The Return of Zen:

Upgrades to the Single-Stage, Single-Ended, Class A Mosfet Amplifier

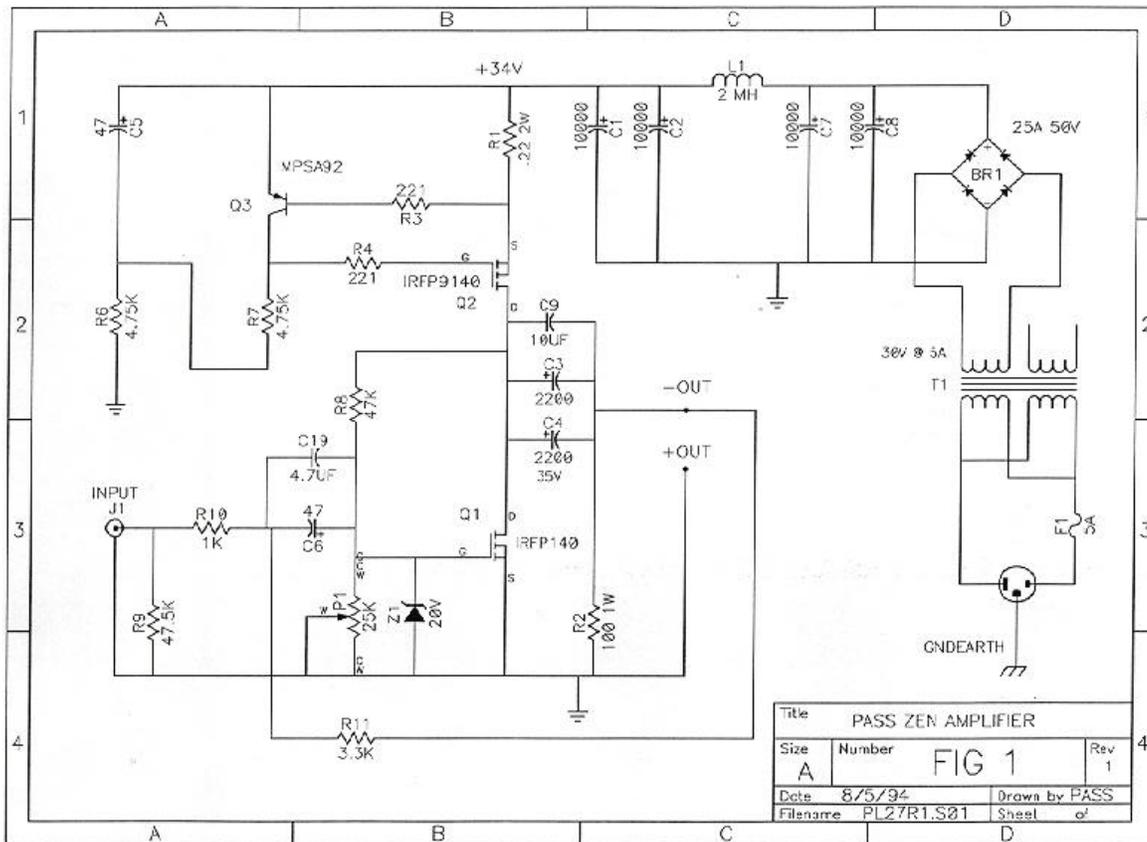
Second, I created a pi filter in the existing supply using an additional 10,000 uF of supply capacitance and a 1 or 2 milliHenry air core coil separating them. This circuit is shown in the power supply portion of Fig 1. I bought the coils from MCM. The result was a reduction of the hum by about 26 dB, which made it generally inaudible.

Several people wrote wanting to know how to eliminate the capacitors from the circuit. This is not a practical thing to do, but there are improvements we can make in this area also. First, it is perfectly acceptable to bypass the electrolytic capacitors with higher quality film types, as shown in Fig 1.

Second, it is easy to restructure the feedback loop of the amplifier so as to enclose both the input and output capacitors in the loop, reducing their distortions by the amount of feedback employed. This is shown in Fig 1, where the values of R8 and P1

have been increased, and two new resistors, R10 and R11 form a separate feedback loop outside the capacitors.

R8 and P1 are still necessary for the purpose of setting the DC bias point of the system, but by making their impedance values high compare to R10 and R11, we allow R10 and R11 to dominate the performance.

Enclosing the DC input and output of the circuit with the R10 and R11 feedback loop also allows us to adjust the gain of the circuit independently of the DC bias adjustment, which comes in handy later.

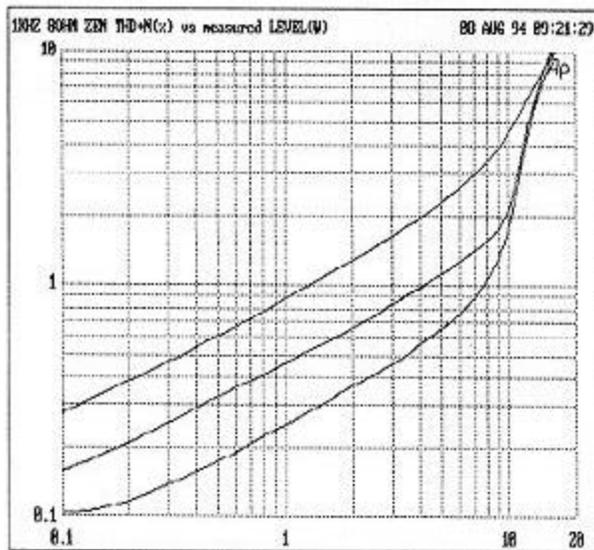
Second, the amount of bias on the Mosfet will make an appreciable difference: Fig 2 shows an IRF140 biased at 2 amps (top curve) and 3 amps (middle curve), and the distortion has dropped by half. The increase in current is accomplished by reducing R1 from .33 ohms to .22 ohms. The dissipation in the power transistors goes up from about 30 watts each to 45 watts, and you want to increase the heat sinking appropriately if you make this change. Also, you should be prepared for a somewhat shorter life span of the amplifier.

Fourth, you can parallel the channels at the input and outputs to obtain still lower distortion figures. The bottom curves of Fig 2 and Fig 3 were obtained by parallel the channels with 3 amp bias.

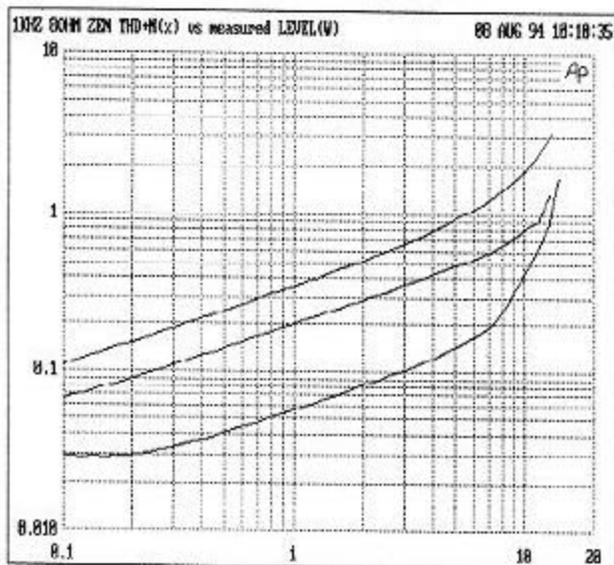
feedback. Fig 3 shows an IRF140 operated with 2 amp bias (top curve) and 3 amp bias (middle curve) with R10 at 1 Kohm and R11 at 3.3 Kohm. The gain figure here is 8.5 dB, and it takes 3 volts to drive the amplifier.

In the case of the bottom curve of Fig 3, we are now obtaining distortion figures 20 dB down from the original circuit, giving the Zen amplifier a cloak of objective respectability. These curves are for the IRF140, and somewhat better measurements are obtained by using an 040. The choice of P channel device is much less important, as it is simply configured as a constant current source.
